Department of Planning,
Housing and Infrastructure
4 Parramatta Square
12 Darcy Street
Parramatta NSW 2150
ATTENTION: Joe Somerville

RE: OBJECTION SSD 85974227 9-17 Balfour St Lindfield Residential development with in-fill affordable housing

Figure 1 – Revit Model Plan

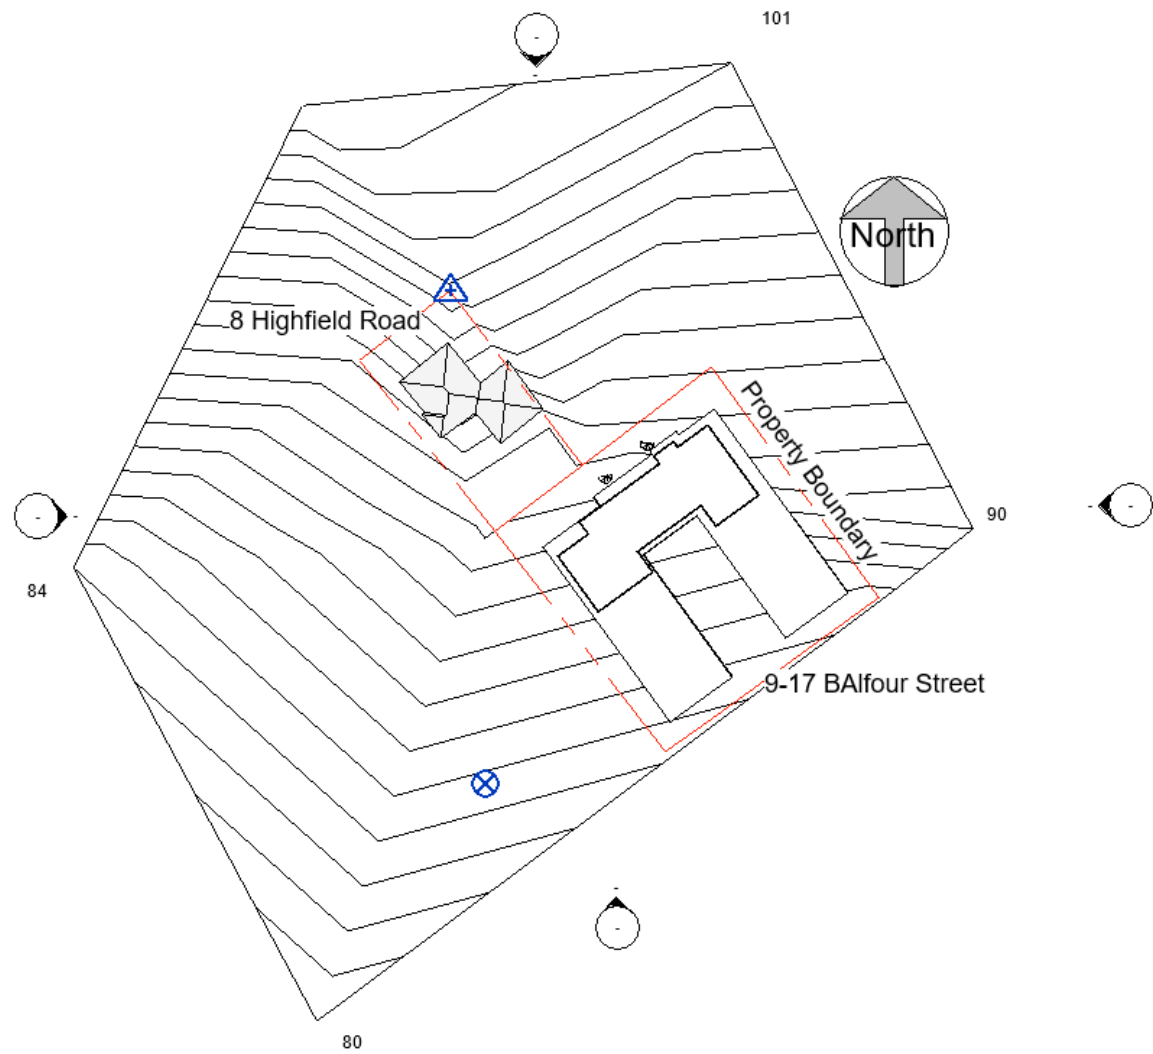
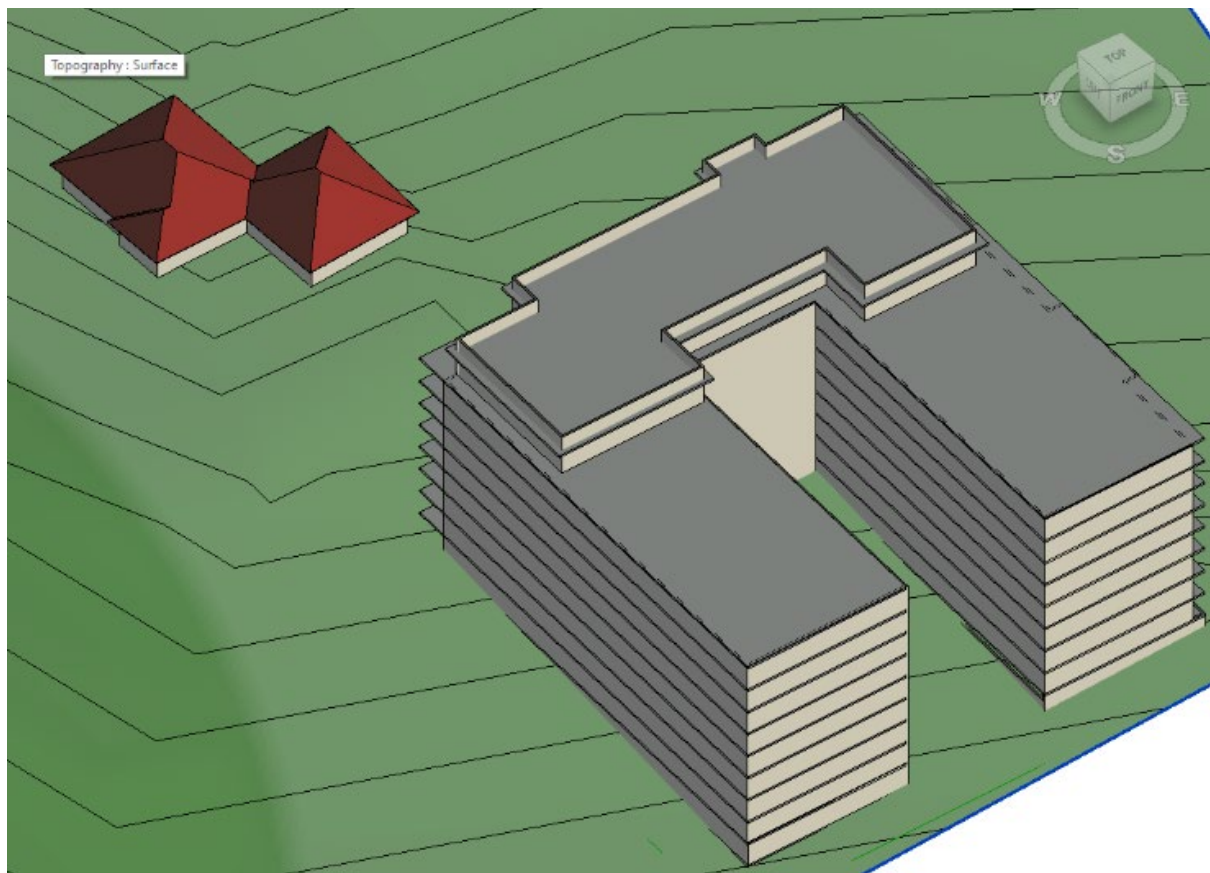
See Annex 1 for figures of the Revit model used.

Figure 3 – Shadows

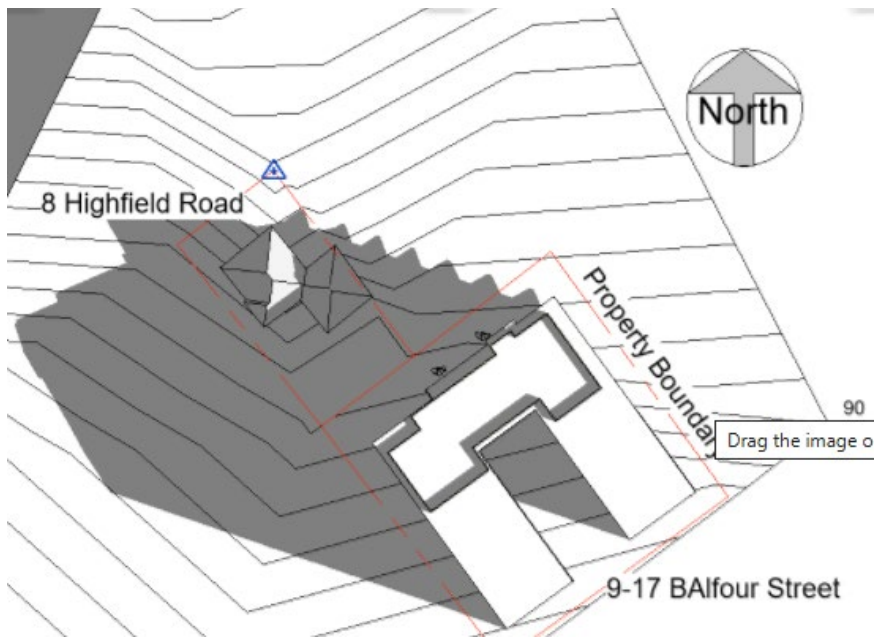
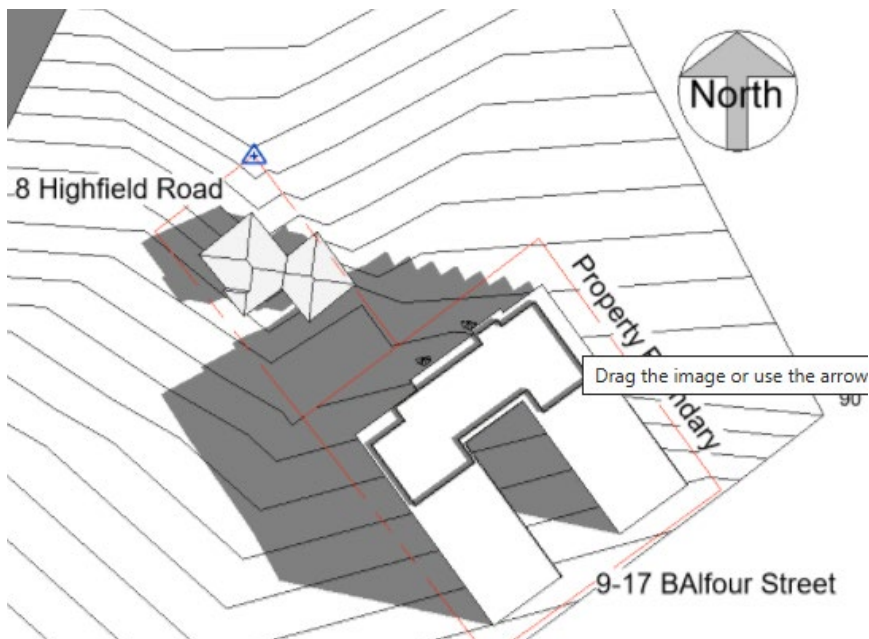
(approximately an hour after sunrise) at the summer solstice the shadows from the proposed development cover most of the residential house at 8 Highfield Road. **See Annex 1 of this objection.**

If a shadows study is carried out using **the summer solstice**, it shows that the proposed development casts a large shadow over neighboring properties and adversely affects their aspects and current sunshine hours. See the sketches below for a shadow study affecting neighboring properties – and in particular 8 Highfield Road. See **Annex 1** of this objection for a view of the shadows cast by the proposed development on adjacent properties. The over shadowing and loss of sunlight have an environmental impact. It will affect the growth of grass and trees on neighbouring properties. It prevents natural heating of swimming pools (including ours) and prevents sunlit clothes drying. Perversely this would lead to increased electricity usage, a resource in short supply.

Revit Model 3D View from the Back Porch of 8 Highfield Road Lindfield

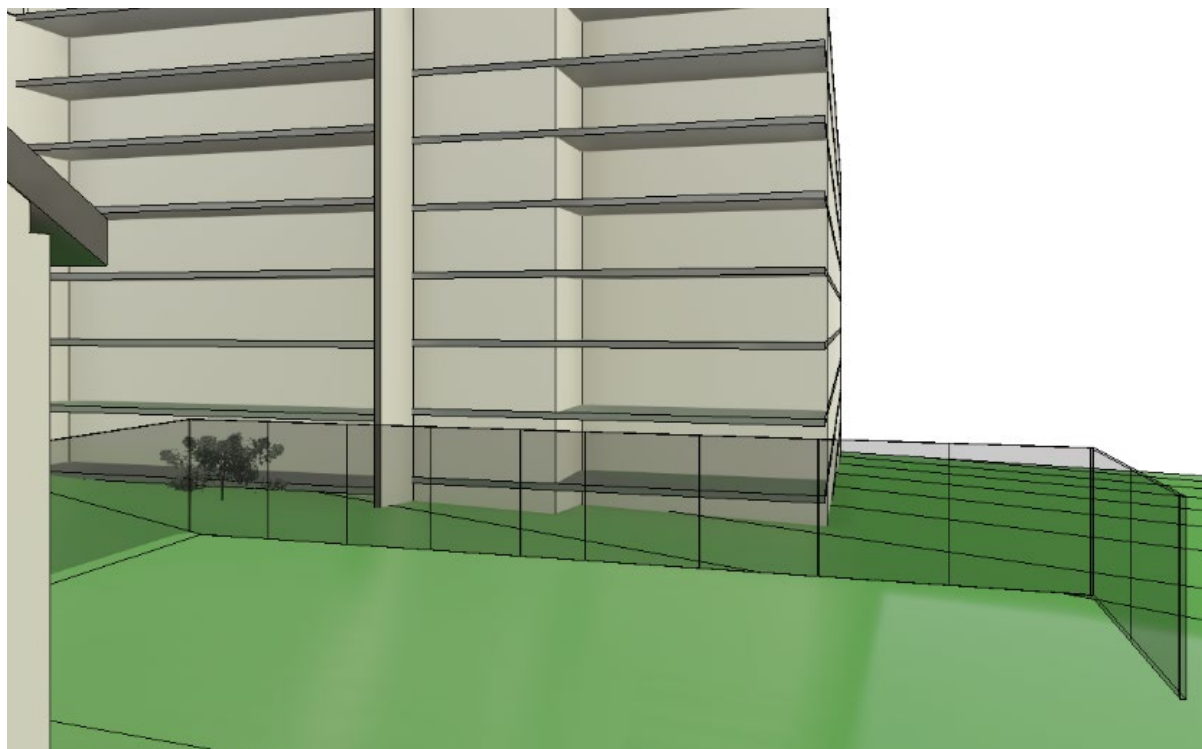
The **Visual Impact Assessment** does not address the impact of the building from the aspect of residents of neighboring and adjacent buildings. These impacts will be substantial and wholly detrimental. The figures (photographs and Revit modeling photo view) in **Annex 2 to this objection** clearly show the extremely adverse impact the proposed development has on the views from neighboring properties.
